DEF Sensor Assembly Routing
 VAH, VHD, VN

FSB 258-036, DEF Sensor Assembly Routing

(March 2015)

W2099961

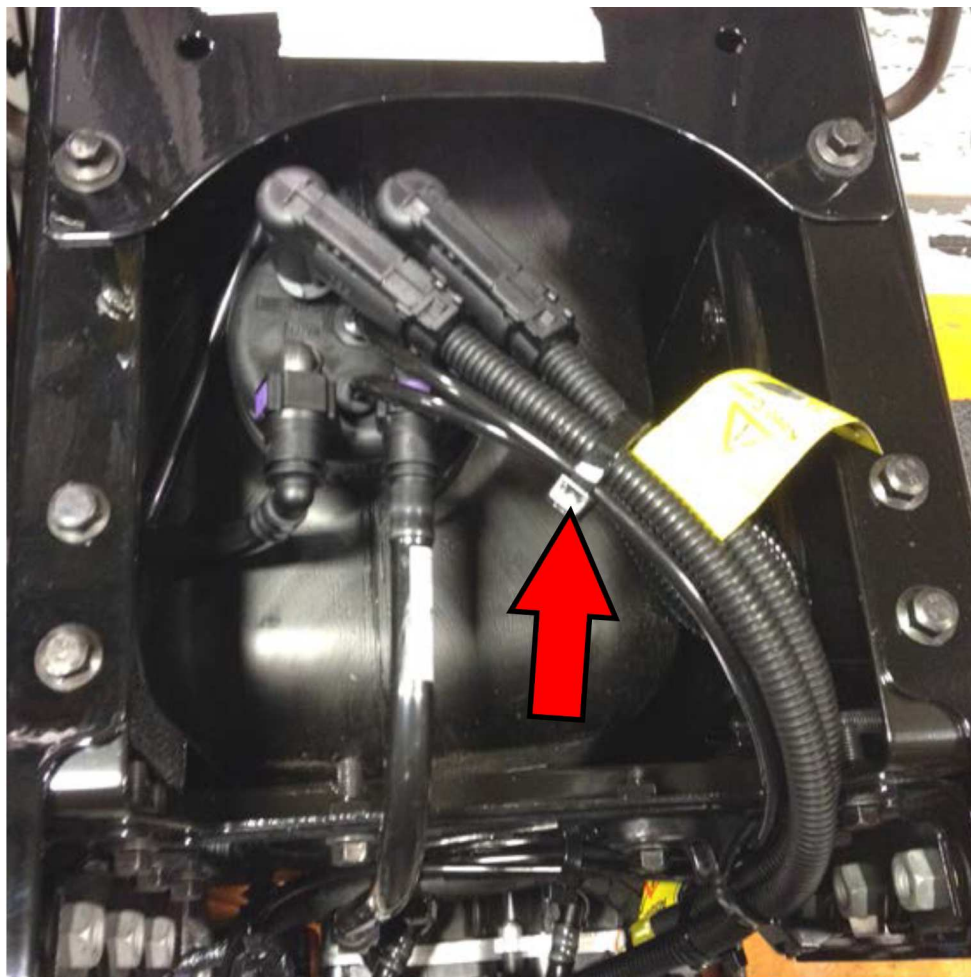
New routing and clipping changes have been implemented for all vehicles assembled after January 5, 2015 in regards to the DEF module harness. The new harness is much stiffer which requires re-routing to avoid cable stress. This also applies to any previously built vehicles when the DEF sensor assembly is replaced.

Route and tie the harness as shown

W2099962

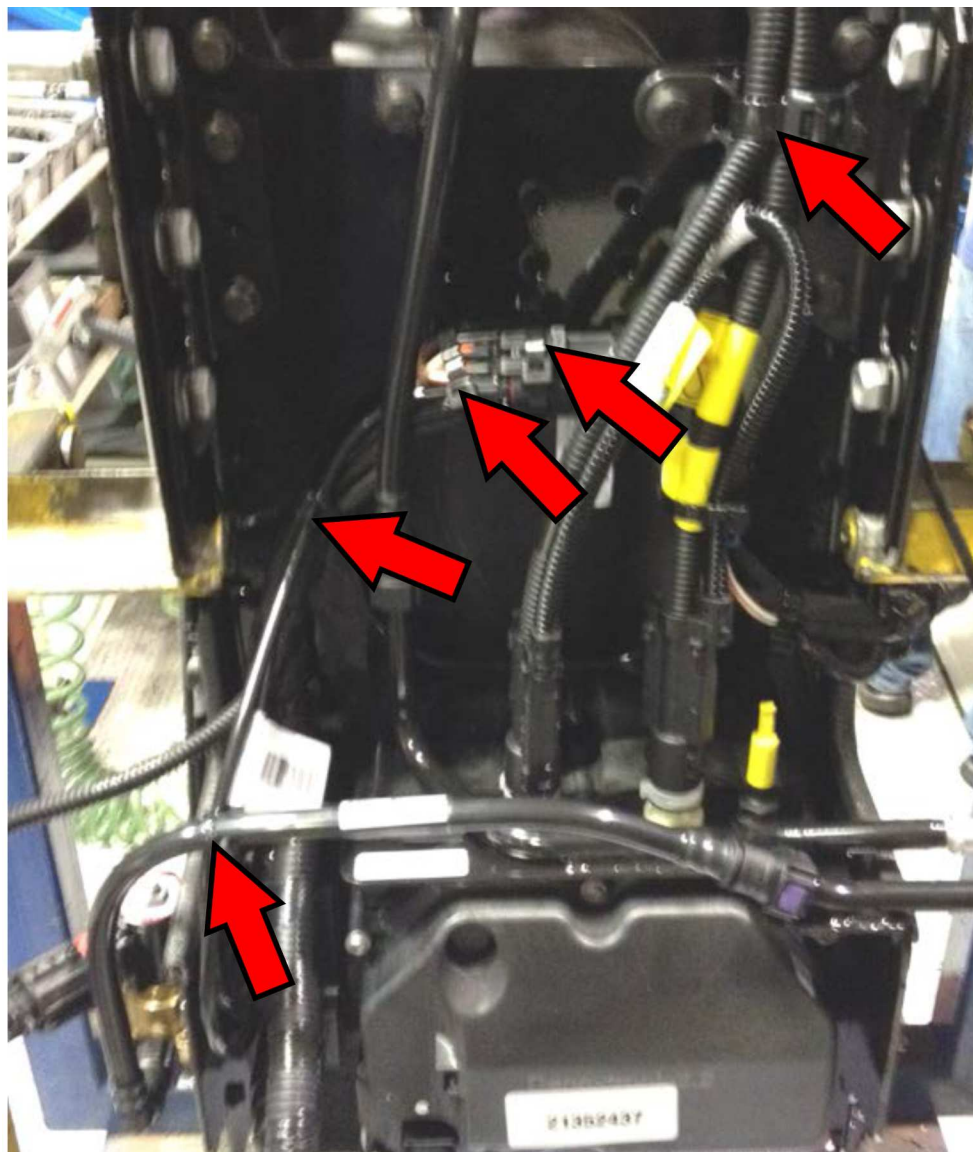
VNL with Cummins ISX Routing
